## Additional Generalized Future Land Use Map Comments 6/8/18

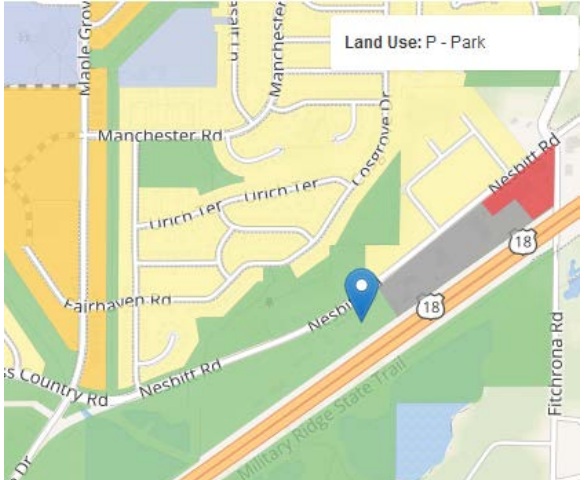
8	5/29 Krauskopf Message	Why was the Carey Ct. area changed from LR to LMR?	LMR is based on the current unit mix for the area (mix of single-family, duplex, and 3+ DUs). The message does not make a request to change the GFLU designation. See the discussion below for a location map and further analysis.	Maintain LMR.	N
9	5/29 sjkrausk Message (#1)	<p>Restrict buildings on the 2000 block of East Washington (on the N side) to two stories.</p> 	Staff interprets this as a request to change the area from LMR to LR. This area, along with the Options in Community Living apartments to the southwest and the E. Washington Ave. frontage to the northeast, were LDR in 2006. Staff reclassified the area with the addition of LMR as a category with this Plan update. The block bounded by Carey Ct., 2 <sup>nd</sup> St., E. Washington Ave., and 3 <sup>rd</sup> St., is made up of small-lot single family (generally 2,900-3,700 square foot lots), with three duplexes and one three-unit. This development is less intense than other LMR-designated areas to the southwest, southeast, and northeast, but the block is different than the exclusively single-family block to the northwest.	Maintain LMR.	Y

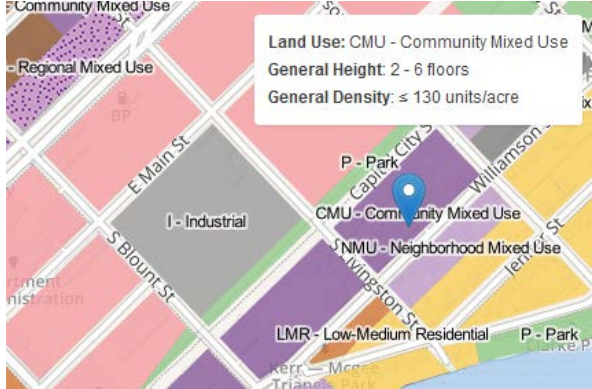
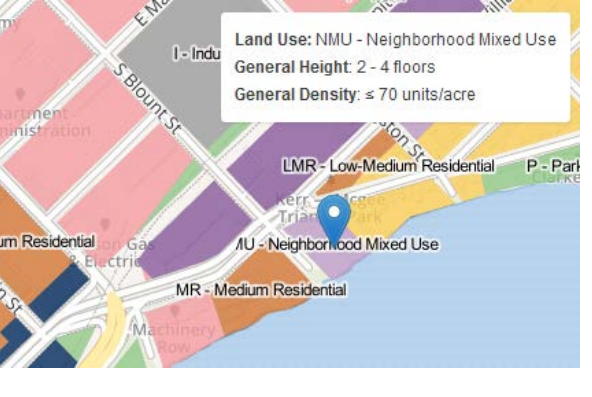
10	5/25 Dwyer & Lathrop Email	<p>Change Les Chateaux Apartments from MR to LMR to better match the Hoyt Park Neighborhood Plan designation of 16-25 DU/acre and 2-3 stories.</p> 	The Comprehensive Plan focuses on building form over density, and the building form and site layout of Les Chateaux Apartments, which has 128 units in 7 buildings on 8.5 acres, is more appropriate to the MR category. An LMR designation for this area, which is not along an arterial road, would be an indication that the type of building that currently exists is not appropriate for the area. This request is similar to the Marquette Neighborhood Association request to change the Fauerbach Condominiums from MR to LMR – while the parcel may meet the density range for LMR, the building form is not appropriate for LMR. MR is the best category for both existing and potential future redevelopment, which would still need to operate under the Neighborhood Plan.	Maintain MR designation.	N

11	5/25 Dwyer & Lathrop Email	<p>Change parcels along Harvey St. between Schmidt Pl. and Hill St. from MR to LMR to better match the Hoyt Plan designation of 2-3 floors and 16-25 DU/ac.</p> 	<p>The area described at left is <b>not</b> specified for 16-25 DU/ac in the Hoyt Plan. In fact, the plan states that the area has “opportunity for higher density uses through lot assembly and redevelopment.” The area in question (area G on page 36 of the Hoyt plan) is specified to transition from taller buildings along University Avenue to a 2-3 story maximum along Harvey Street. 2-3 stories is within the MR range. The Comp Plan residential categories not only address height, but also building form. Staff feels that the building forms within the MR category are more appropriate for this area than the LMR category. The recommendations in the Neighborhood Plan as far as a 3 story height limit will remain.</p>	Maintain current MR designation.	N

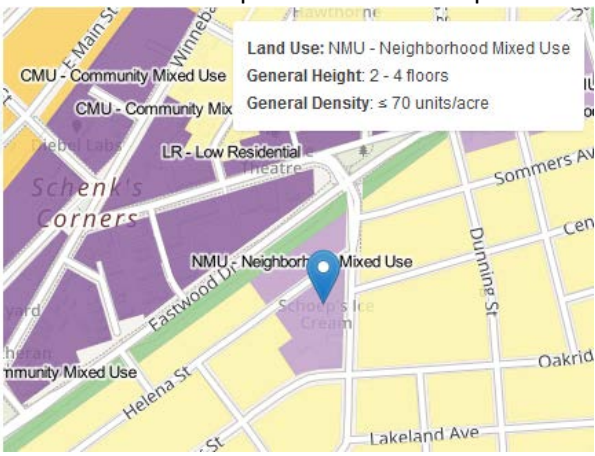
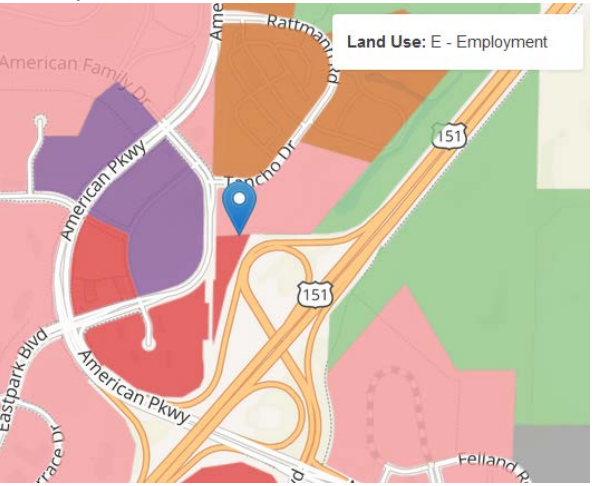
14	5/11 O'Donnell Messages	Retain MR for land between W. Washington and W. Main south of Proudfit. The block bounded by W. Main, Proudfit, Brittingham, and S. Brittingham should remain LR.	See #17 below for MR/HR discussion. The Commission instructed staff to change the block bounded by W. Main, Proudfit, Brittingham, and S. Brittingham to LMR at their 6/7/18 meeting.	Comment addressed at 6/7/18 PC meeting.	N
15	5/19 Leigh Email	Leave the entire block from W. Main, Proudfit, W. Brittingham and S. Brittingham as LR.	The Commission instructed staff to change the block bounded by W. Main, Proudfit, Brittingham, and S. Brittingham to LMR at their 6/7/18 meeting.	Comment addressed at 6/7/18 PC meeting.	N
16	6/5 Pelski Email	<p>“the neighborhood and its residents, after several meetings and discussions, strongly oppose adjusting zoning/height restrictions from the 2006 plan to High Density for the Properties between West Washington, Proudfit, and West Main St; these properties are known as Parkview Apartments, Journey and the vacant property on the corner. Additionally, the Monona Bay neighborhood and its residents oppose moving from low-density for the block surrounded by West Main Street (700 block), South Brittingham, West Brittingham and Proudfit streets. Finally, the properties on the West Shore of Monona Bay will be addressed in our plan, and we ask that we maintain the 2006 plans regarding height and density.”</p>	See discussion below regarding HR/MR for the Parkview Apartments. The Commission instructed staff to change the block bounded by W. Main, Proudfit, Brittingham, and S. Brittingham to LMR at their 6/7/18 meeting.	See #17 below.	N

17	5/10 Pelski Email	<p>Keep the Brittingham area with the same FLU as the 2006 Plan.</p> <p>Include the area in the City’s renter-occupied to owner-occupied grant programs that had been developed for Greenbush and Tenny.</p> 	<p>The Commission instructed staff to change the block bounded by W. Main, Proudfit, Brittingham, and S. Brittingham to LMR at their 6/7/18 meeting.</p> <p>As discussed at the 6/7/18 PC meeting, the Parkview Apartments area will be split between HR along W. Washington and MR along W. Main St. HR remains appropriate along W. Washington due to the area’s excellent transit access, proximity to downtown and employment, adjacency to a park and community gardens, excellent access to the shared-use path network, and location close to shops and a grocery store.</p> <p>Strategy 6-c in Neighborhoods and Housing addresses the second comment. Inclusion in such a program would require a tax increment district be created for (or adjacent to) the area.</p>	Implement GFLU edits as discussed at left.	Y
